Airly Mine Extension Project

Review Report

November 2015

Figure 1: Proposed Mining Zones

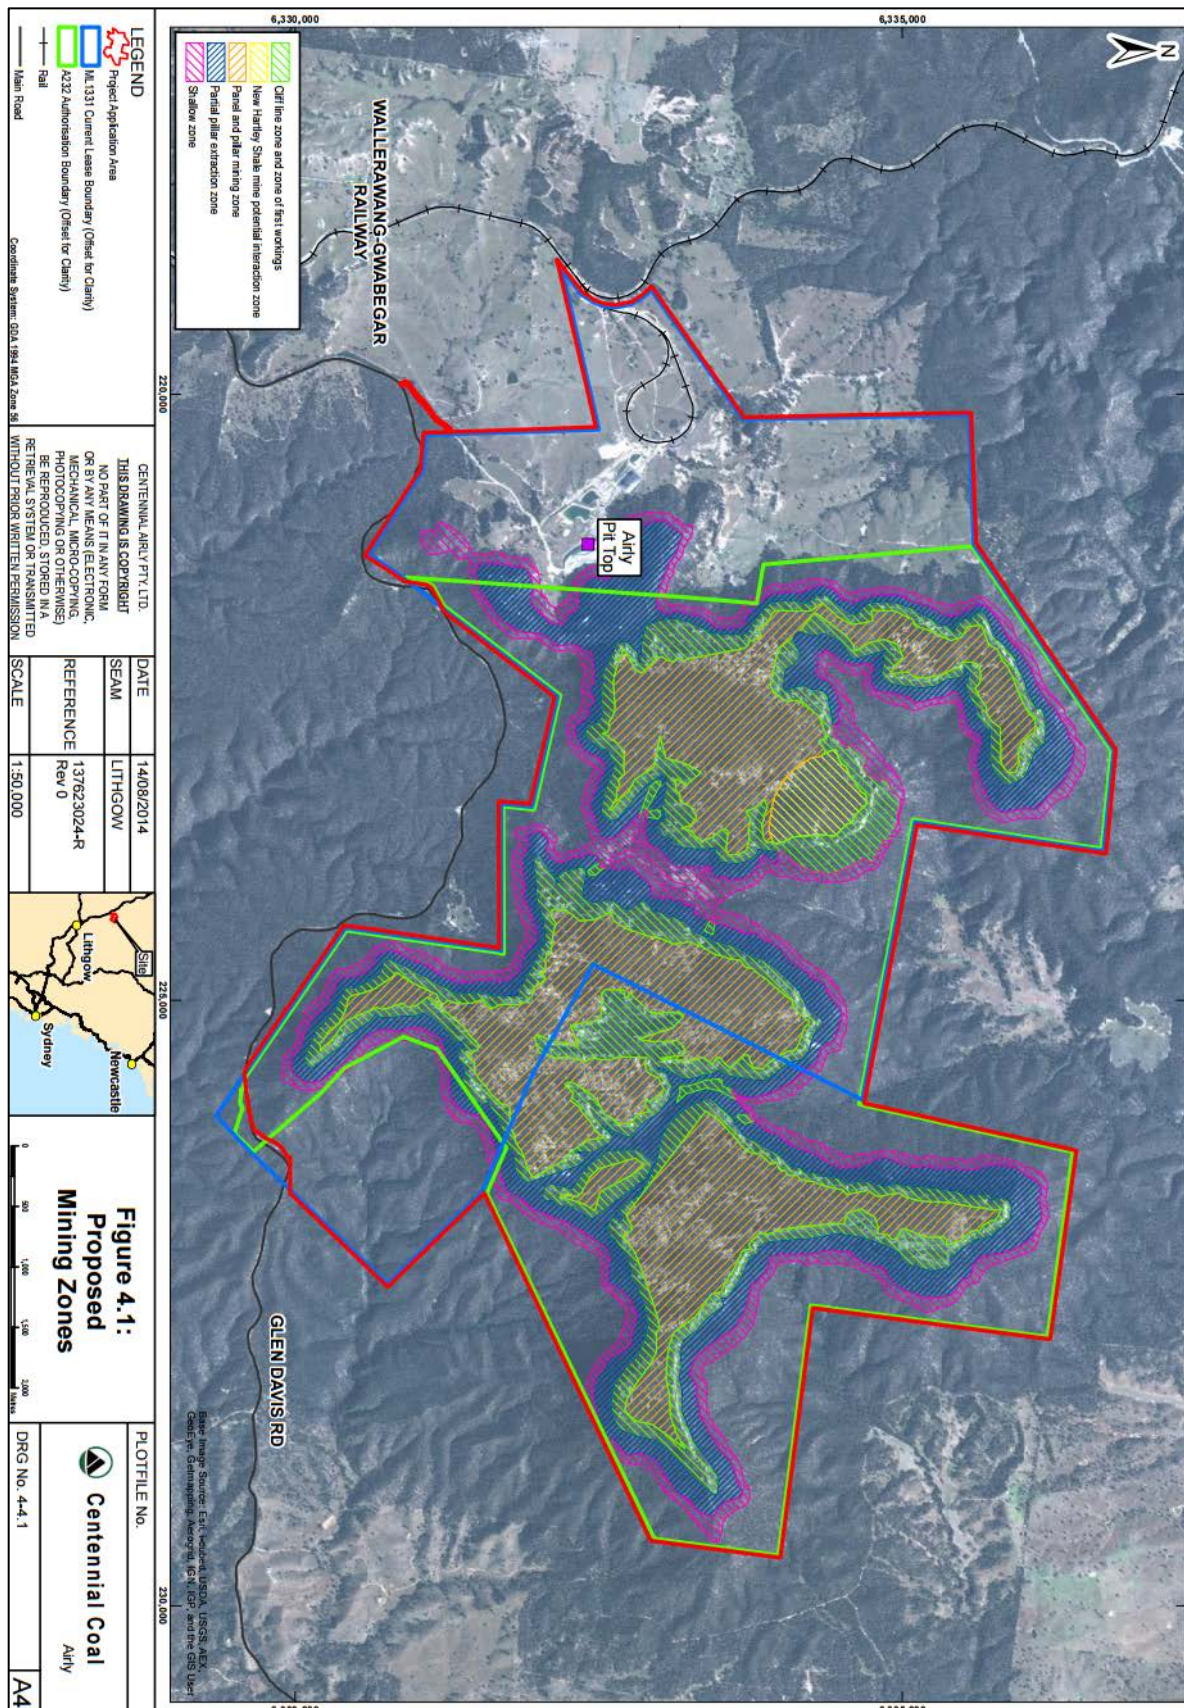
The Commission notes that the project has been divided into five distinct mining zones with each representing a specific geotechnical environment (see **Figure 1** on the next page).

While the Commission acknowledges that bord and pillar mining is more flexible than longwall mining and may involve amendments to mine plans throughout the process to minimise risk to surface structures, the lack of a predicted timetable describing the likely sequence of mining has made the task of assessing the potential subsidence impacts more difficult, particularly in relation to those impacts that are likely to occur in the early stages of the project. The Commission considers that such a timetable enhances certainty in decision-making and recommends that the Department require the Applicant to provide a proposed timeline of coal extraction, including a plan showing the expected progression of mining over the 25 year project life.

1. That the Department requires the Applicant to provide a proposed timeline of coal extraction, including a plan showing the expected progression of mining over the 25 year project life.

Figure 4: Watercourses and Proposed Mining Zones

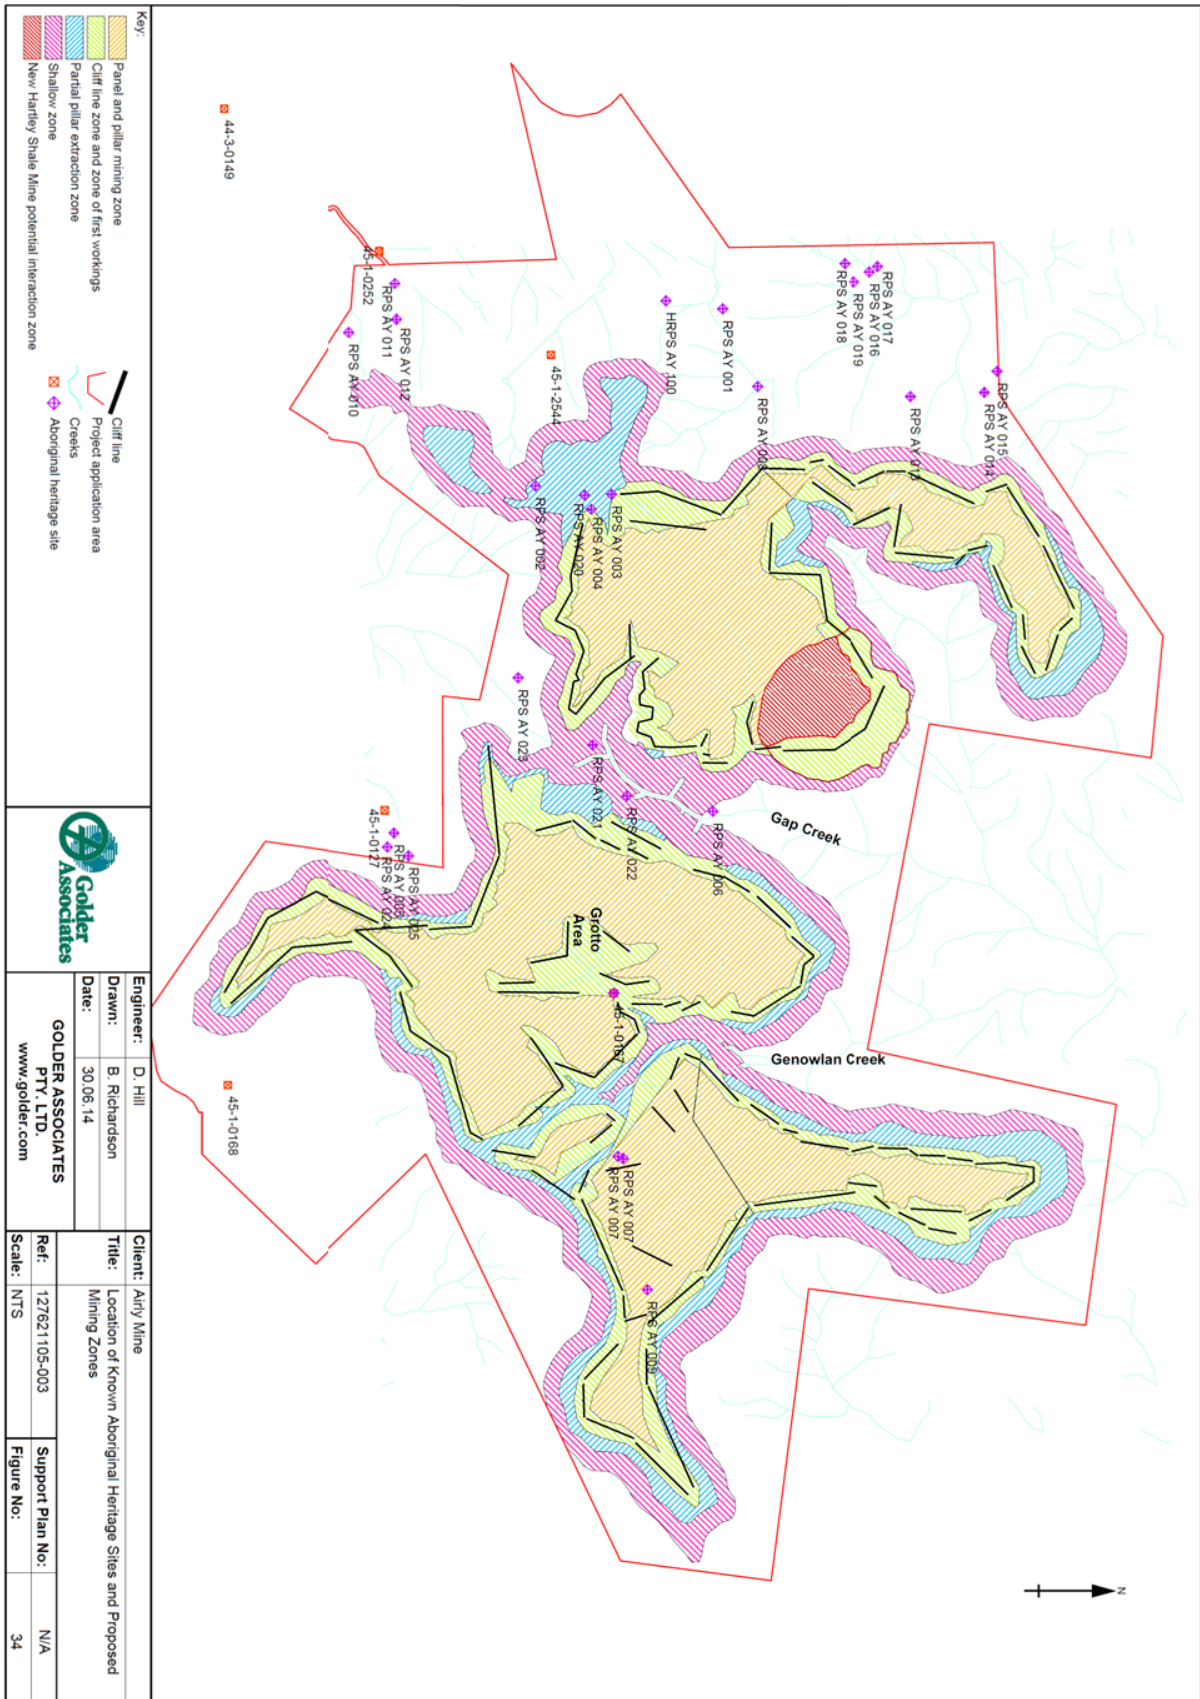
However, the Commission notes there is potential subsidence-related surface cracking of two first order drainage lines, which are located within the Interaction Zone (refer to **Figure 4** on the next page). The potential loss of water in these drainage lines may lead to a minor reduction in flow downstream in Gap Creek and Genowlan Creek (both third order streams), which are located outside the Interaction Zone. The SWIA predicts that even if the two first order drainage lines are drained completely, this would reduce total catchment runoff by less than 9.5% in Gap Creek, and less than 2% at its confluence with Genowlan Creek.
